PROPOSAL:

to permit the construction of a 20-storey mid-rise apartment building consisting of 175 dwelling units in Guildford. A variance is proposed to reduce the minimum on-site parking requirement and to increase the permitted lot coverage under the CD Zone.

LOCATION: 15200 Guildford Drive

OCTOBER - 2023
Response to ADP-2023-10-26 File No. 21-0153

FLARE
FIREPLACES

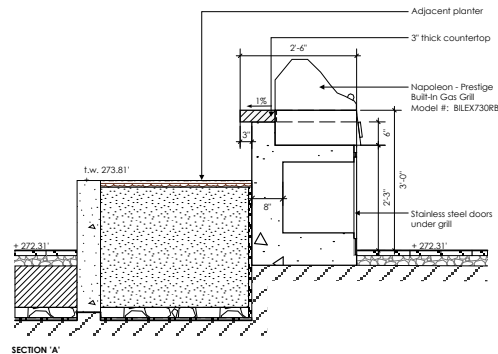
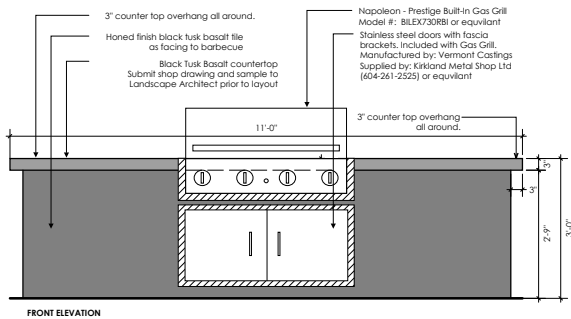
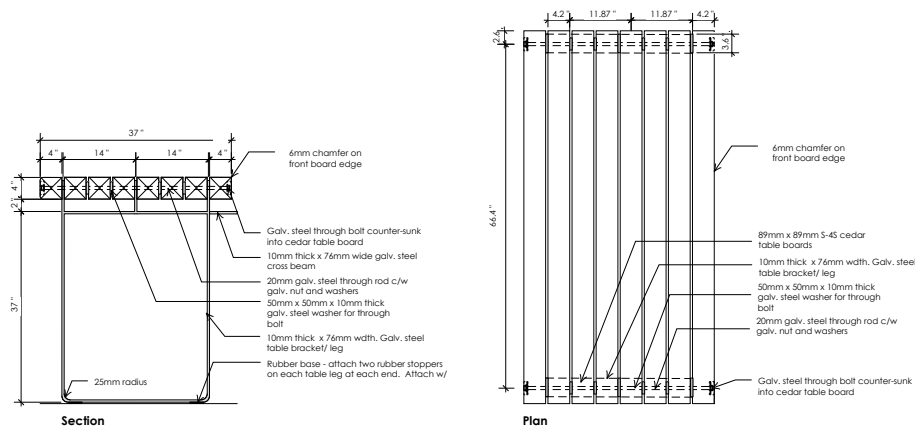
- Reconsider the use of gas as an energy source. **Controls (timers, etc) to be added to outdoor fireplace to improve energy use efficiency.**

- Consider electrification of the hot water system. **Current system meets city bylaws**
- Consider alternatives to gas for the outdoor fireplace. **Current system meets city bylaws, a timer will be added to reduce consumption**

Ld-2 4' Wood Fencing at South PL (by walkway)
L-1.1 SCALE 1"=1'-0"

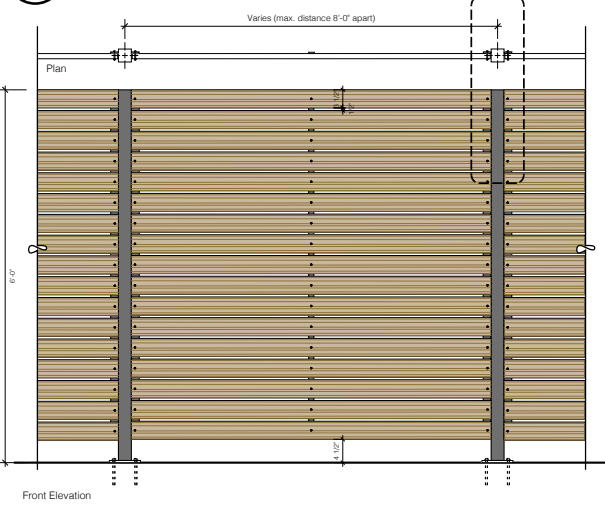
- Consider providing additional buffer between neighbouring buildings and the walkway on south. A fence along the walkway is to be added; additional planting to be considered. Note that the pathway design has been created at request of neighbouring property.

Ld-3 Outdoor kitchen on Rooftop
L-1.4 SCALE 1/2"=1'-0"

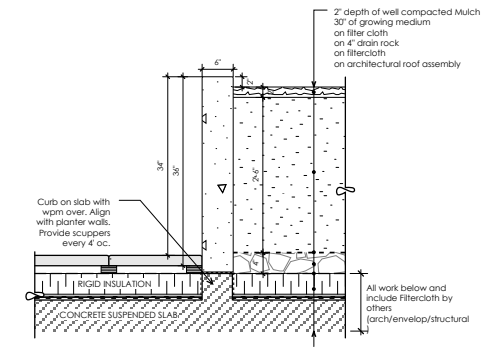
- Consider the addition of seating pods in the outdoor kitchen area to provide more space for small groups and individuals. Bar top tables and stools to be added in outdoor area.

- Consider the addition of a barbecue in the outdoor kitchen area, and similarly, a counter tops and functional cooking spaces. BBQ located in outdoor kitchen area is already present on provided ADP drawing set.
